BEAUMONT-CHERRY VALLEY WATER DISTRICT
PIPELINE RELOCATION PROJECT for BEAUMONT MDP LINE 16
CONTRACT DOCUMENTS

ADDENDUM NO. 1

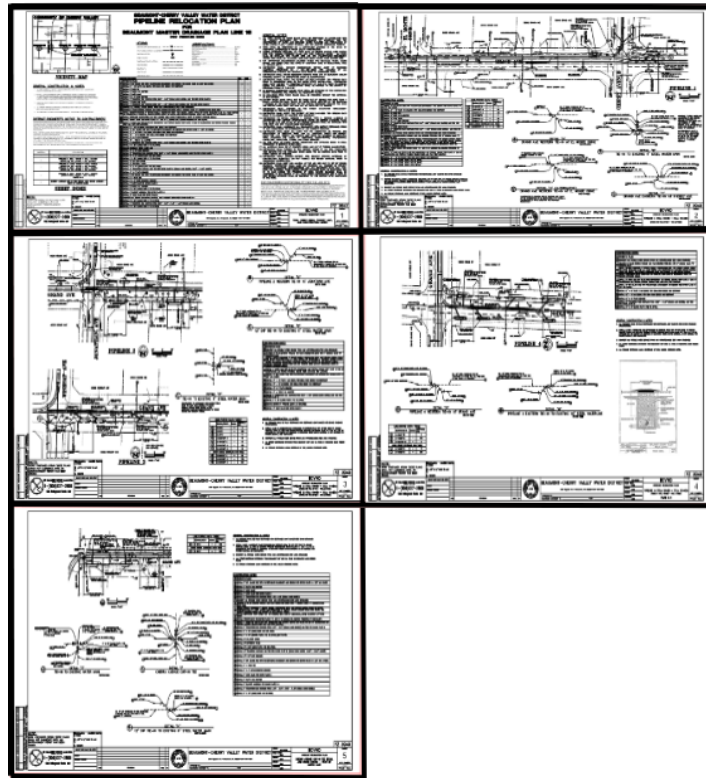
1. **Reference:** Beaumont-Cherry Valley Water District Pipeline Relocation Project for Beaumont MDP Line 16, Contract Documents, Bid Form, Bid Schedule 1

Replace text description of Bid Item 119 (as follows) in its entirety:

ITEM NO.	DESCRIPTION OF ITEMS	EST. QUANTITY	UNIT	UNIT PRICE (FIGURES)	TOTAL AMOUNT
119	Install District furnished valves, fittings, and appurtenances at Pipeline 3 – Station 12+37± (Grand Ave. Sta. 62+52±) per Construction Drawings Detail E on Sheet 3 and BCVWD Standard Plates 2, 6-1 and 9	1	L.S.

With the following text:

ITEM NO.	DESCRIPTION OF ITEMS	EST. QUANTITY	UNIT	UNIT PRICE (FIGURES)	TOTAL AMOUNT
119	Install District furnished valves, fittings, thrust block, and appurtenances at Pipeline 3 – Station 12+37± (Grand Ave. Sta. 62+52±) per Construction Drawings Detail K on Sheet 5 and BCVWD Standard Plates 2, 6-1 and 9	1	L.S.
